## 138132- CRAINE MASTER BATH

CRAINE 138132

# CRAINE 138132- update 3.25

### MASTER BATH-SHOWER WALL EDGE NEAR DOOR

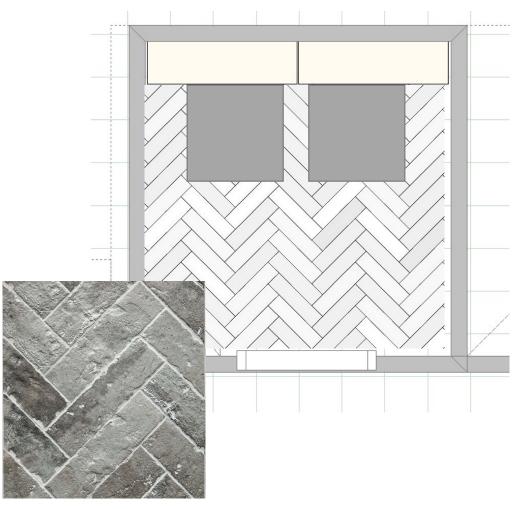
- Exposed ends look unfinished. I cant figured out why it sticks out so far. Why the backerboard is sitting out from finished drywall above door.
- I had a pencil on the job, it wasn't installed, but isn't going to be tall enough to cover the 1 1/8" end. Need a solution.

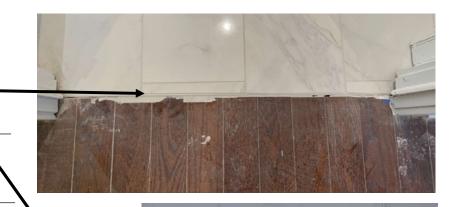
- Door threshold, gaps between wood and metal piece.
- There is damage to the wood, where grout & painters tape were left on the wood. Customer is requesting a marble threshold be added to cover.
- Tile is water closet , has irregular cuts. But I think should be covered with the quarter round.
- When tile was grouted last, it looks like the wall grout was used (Arctic). Instead of the Original Floor Gray: Ash.

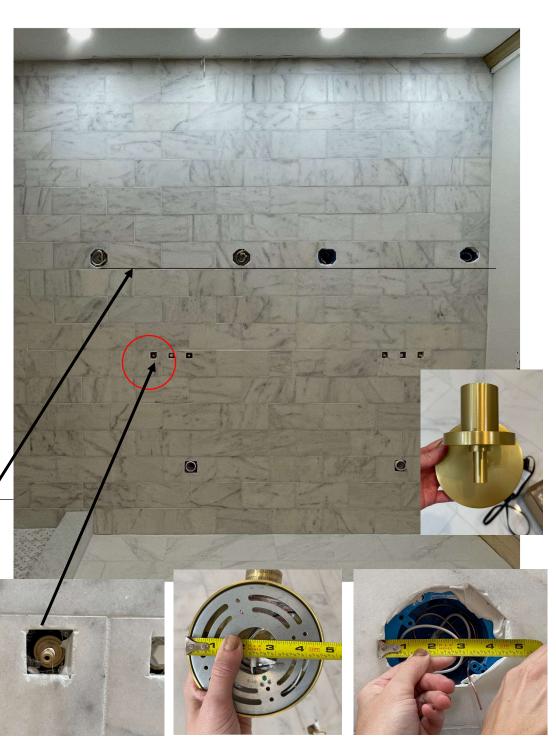
- Pencils around top niche are visibly darker. Customer wants replaced.
- 4 wall sconces, have a @ 1" variation in height from floor to bottom of cutout, from left to right.
- There can be very little adjustment on sconce backplate location, because size of cut-out is almost bigger than backplate in some areas. Tile will need to be replaced & recut.
- Check left faucet handle cutout left sink. Damaged stone may be seen outside of the faucet backplate

### LAUNDRY ROOM- (off of family)

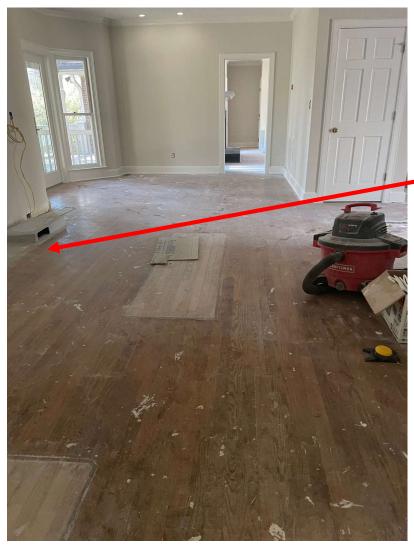
- Homeowner mentioned in notes over the weekend that the tile was a mess. Needed to be cleaned.
- There are 3 full boxes left over. To be returned.

### GARAGE HALLWAY/POWDER (off of kitchen)-

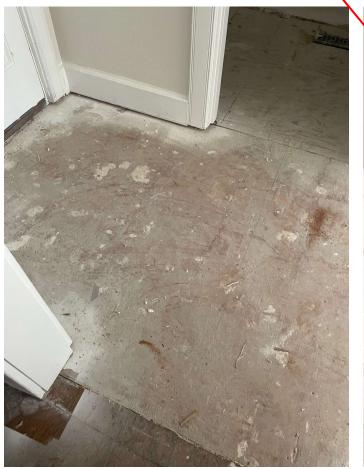
- New wood is being installed.
- Subfloor of hallway and existing hardware are at the same level. Need a transition for the height difference?
- Powder Room sink is a freestanding furniture piece. Wood install before cabinetry install.
